Greenhill Industrial – Pre Meeting Feedback Summary

To:	Fraser McNutt (B&A)		
From:	Denzil Govender (HCC)		
Subject:	Greenhill Industrial - Pre Meeting Feedback Summary		
Date:	21 November 2025	File:	n/a

Project Name	Fast-Track	# of meeting notes	001
Meeting	Greenhill Consultant Presentation and Discussion	Date of meeting	26/11/2025 (11am)
Location	Teams/Rototuna Meeting Room	Notes taken by:	Jaimee Wilson

Figure 1

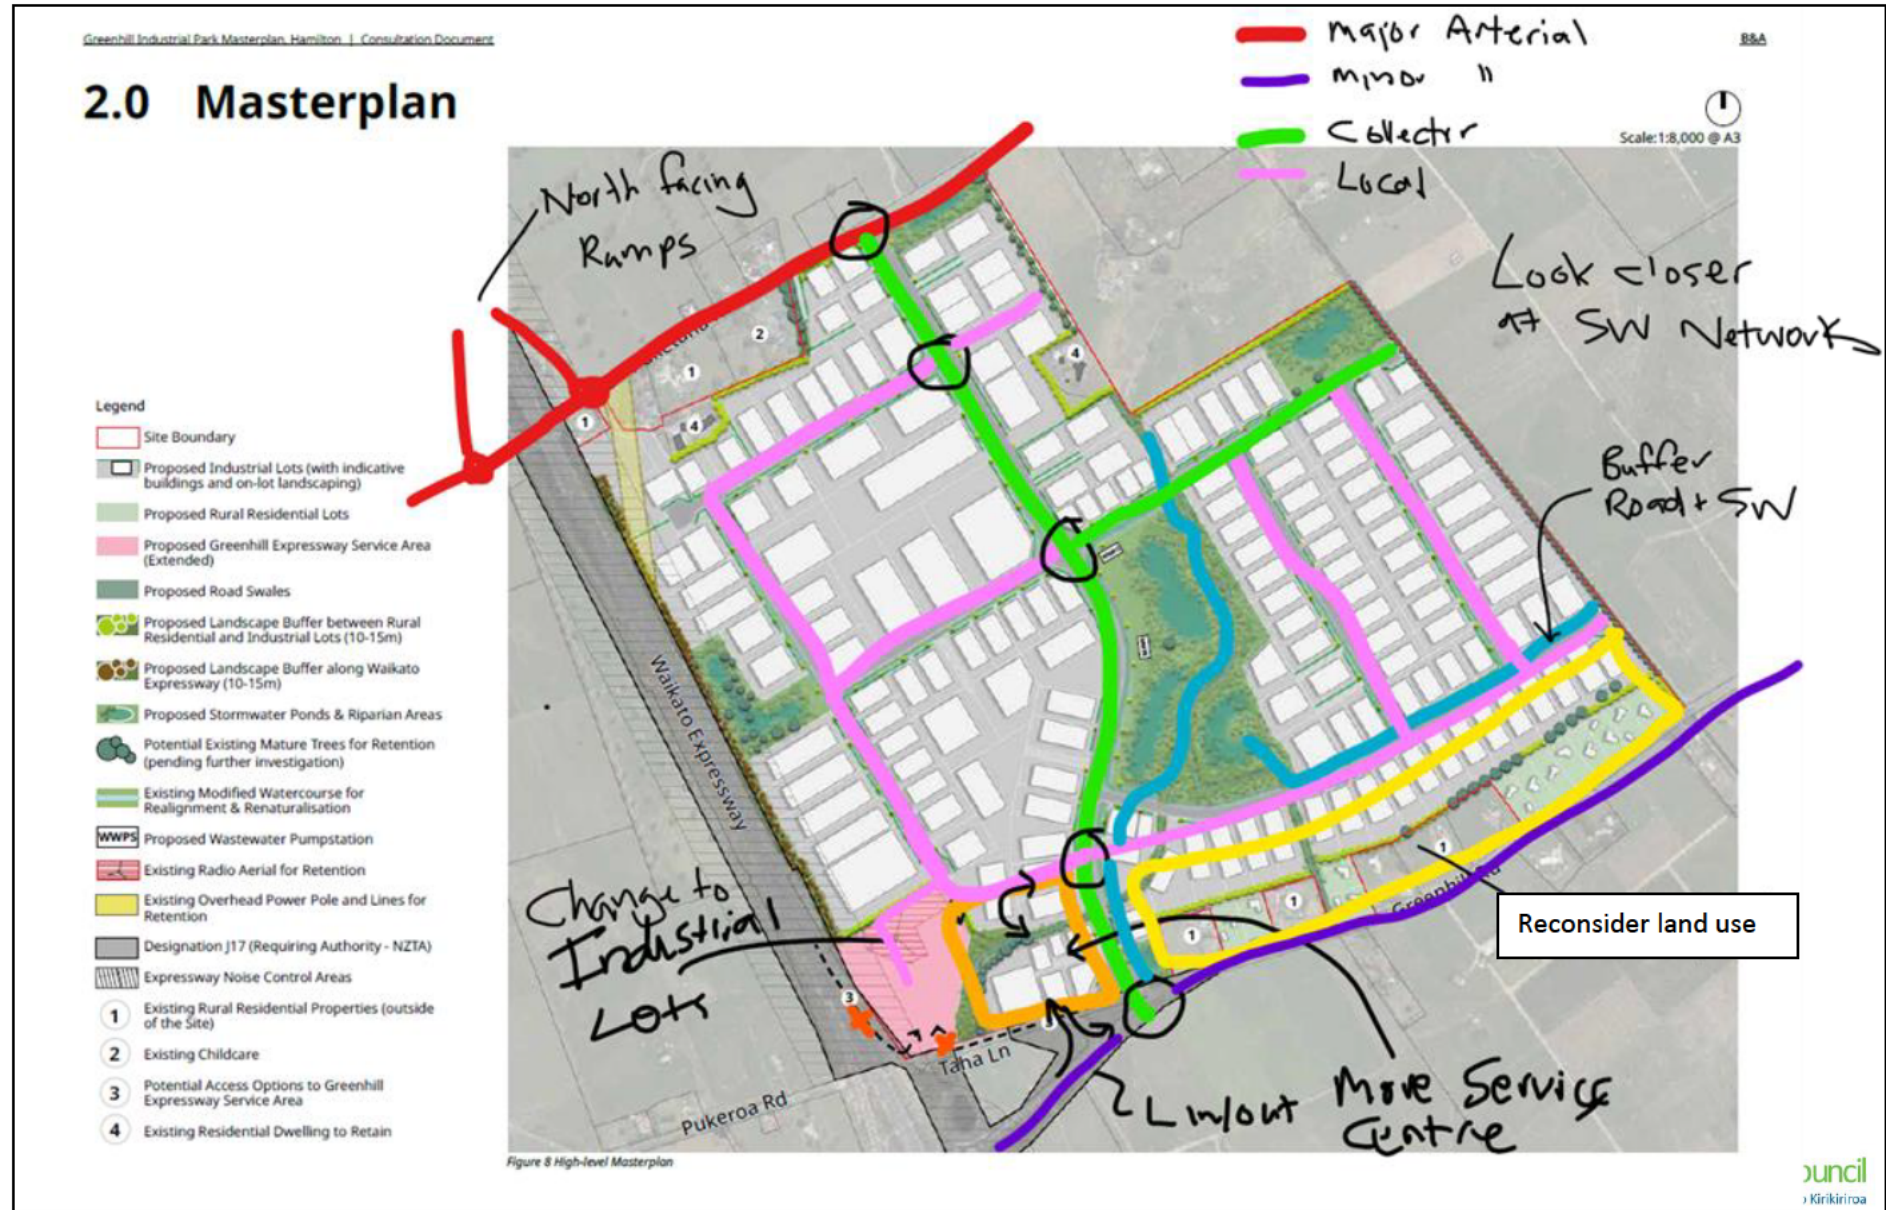
- **Initial HCC Transport layout feedback (see Figure 1):**
 - o Please note the feedback illustrated in Figure 1 is preliminary and high-level, presented for discussion purposes only. Where improvements or changes to public road networks are shown, these are not confirmed and may not reflect the view of all Future Proof partners.

- o Consider incorporating additional roundabouts along the proposed collector road to enhance traffic efficiency. Note that roundabouts are already proposed at the intersections of the collector road with Greenhill Road and with a local road near the site's centre. Additional roundabouts should be included as indicated in Figure 1.

- o Review the proposed western local roads to eliminate cul-de-sacs where possible and ensure continued connectivity to the eastern portion of the development.

- o Consider the upgrade of Puketaha Road.
 - o Reconsider the proposed service centre location and extent to optimise accessibility and integration with the network.
